CITY PLANNING COMMISSION

APPLICATION: Special Permit to allow a drive through window for a restaurant located in a General Commercial (C-2) zone

LOCATION: 5550 Sacramento Boulevard

APPLC. NO. P86-161 MEETING DATE May 22, 1986 ITEM NO. 17

EXHIBIT A SITE PLAN

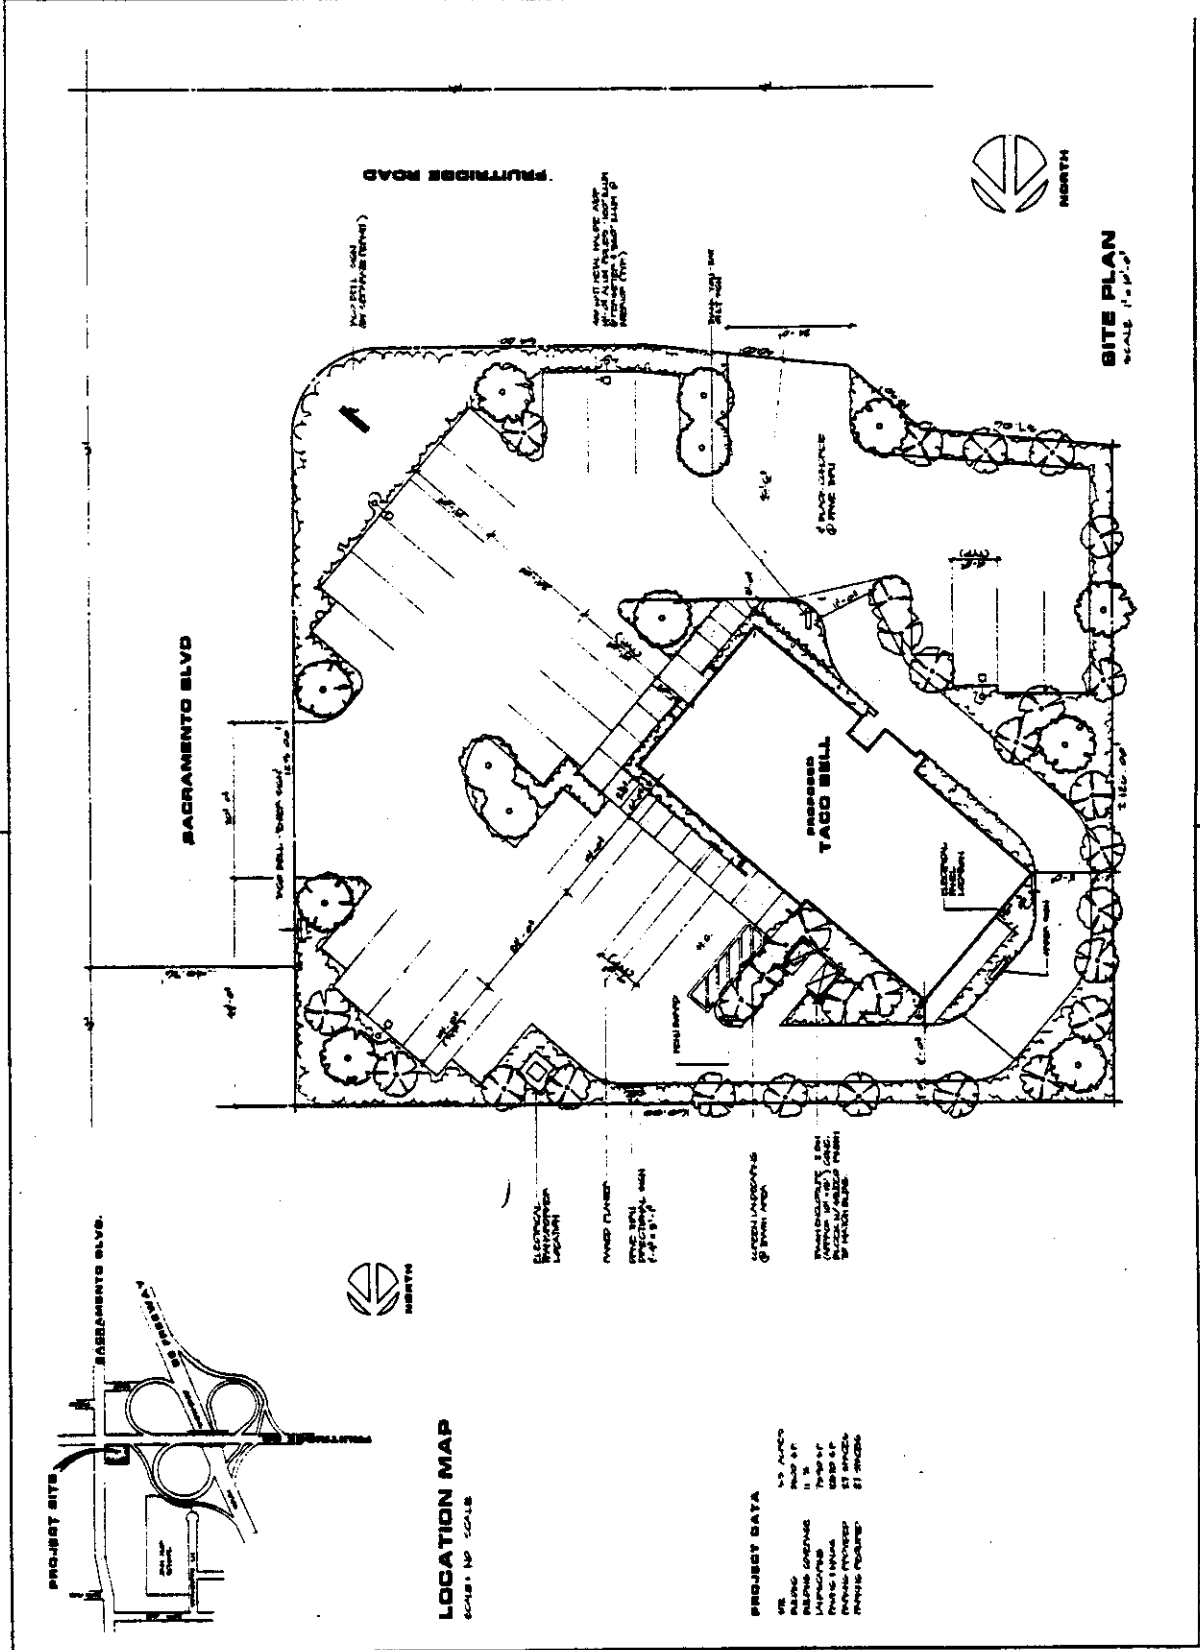
The building will be set at an angle at the rear of the property so that the stacking lane for the drive through window is situated close to the two interior property lines; therefore, a masonry wall is required between the stacking lane and the adjacent nursery school.

- C. The parking plan for the project shows most of the parking stalls placed at various angles to the property lines. This creates a lack of sufficient maneuvering area for several parking stalls. Also, there is inadequate truck access to the trash enclosure. The Traffic Engineer has stated in his review of the project that the Fruitridge Road driveway should be farther from the freeway ramp and be 30 to 35 feet wide; and that the Sacramento Boulevard driveway should be closer to the north property line to provide better intersection clearance.

The applicant can provide a two-foot automobile overhang into the landscaped area which will provide some additional maneuvering area; however, since the driveways require relocation and widening, and access to the trash enclosure needs to be improved, staff is requiring the applicant re-design the parking area to satisfy the above mentioned concerns. This re-design must be submitted to staff prior to review of the project by the Design Review Board.

- D. The plans submitted indicate a pole sign at the southeast corner of the site, and three attached signs for the project. These will require review and approval by the Design Review Board.

1. The applicant shall submit a revised parking plan indicating sufficient maneuvering area, trash enclosure access and relocated driveway access to staff prior to review by the Design Review Board.
2. The applicant shall provide a six-foot high masonry wall along the western property line.

EXHIBIT B
NOIATIONS

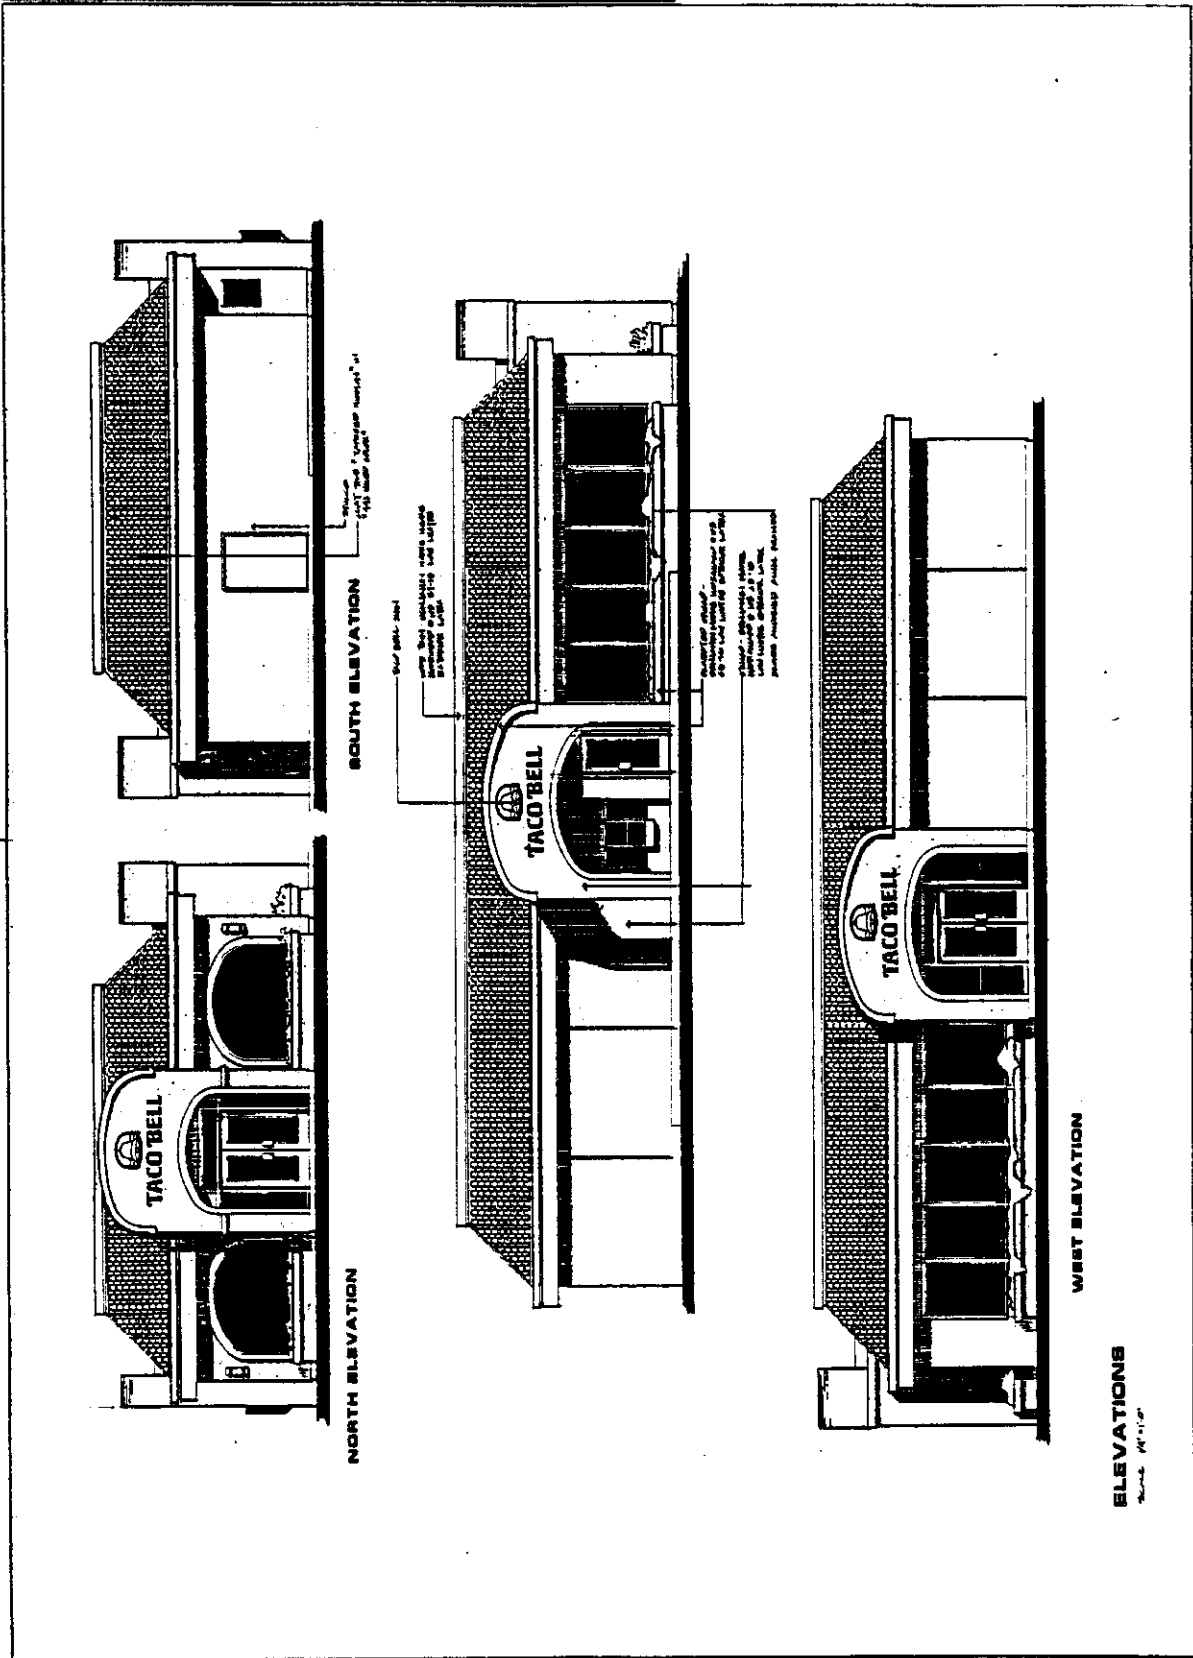
The elevations show stucco walls with a dark red clay tile roof. The building design is subject to review and approval by the Design Review Board as the subject site is located within the Oak Park Redevelopment Area.
